**REQUEST**

Current Zoning: R-4 (single family zoning)  
Proposed Zoning: UR-1(CD) – (urban residential, conditional)

Approximately 1.35 acres located west of Margaret Wallace Road, northeast of Glen Lyon Drive.

## PLANNING STAFF REVIEW

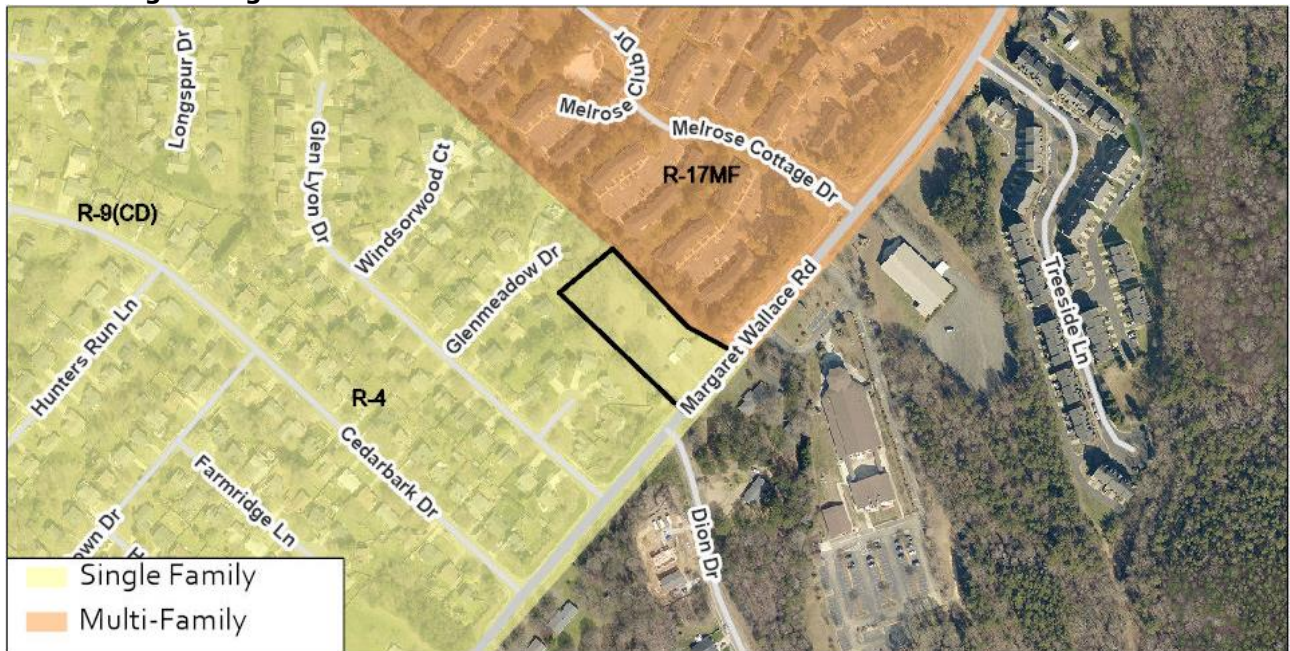
1. ~~Revise the site plan to show, label and dimension the 50' right of way from the road centerline on the site plan and add a conditional note to commit to dedicate 50' right of way from the road centerline to meet CRTPO guidelines for R/W on a major thoroughfare.~~ **Addressed.**

2. ~~Add a note specifying dedication and fee simple conveyance of all rights of way to the City before the site's first building certificate of occupancy is issued. CDOT requests right of way set at 2' behind back of sidewalk where feasible.~~ **Addressed.**

3. ~~Revise the site plan to show the left turn lane into the site and add a conditional note committing to the provision of a left turn lane into the proposed street connection of the site.~~ **Addressed.**

4. ~~Revise the site plan and conditional note(s) to connect to existing sidewalk and extend to Glen Lyon Drive to complete the pedestrian infrastructure for this block and help with meeting the City Council Adopted Charlotte Walks Policy.~~ **Rescinded, existing sidewalk extends to Glen Lyon Drive.**

5. ~~Add the following note under the ENVIRONMENTAL FEATURES heading: "The petitioner shall tie into and analyze the adequacy of the existing storm water conveyance to the nearest public right of way. If the existing storm water conveyance is found to be inadequate, the Petitioner shall make a good faith effort to improve the storm water conveyance or mitigate the storm water discharge."~~ **Addressed.**

6. ~~Amend the Rezoning Summary table to reflect a 17 ft rear yard as specified in the development note.~~ Addressed.
7. ~~Amend the Rezoning Summary table to specify that a 20 ft garage setback is required between the sidewalk and the face of the garage along the internal street.~~ Addressed.

8. ~~Revise the site plan and conditional note(s) to specify the petitioner will construct an 8' planting strip and 6' sidewalk behind the curb and gutter to be installed.~~ Addressed
  9. ~~Revise the site plan and conditional note(s) to construct the "private street" to meet USDG standards per the subdivision ordinance. CLDS U-03A.~~ Addressed
-
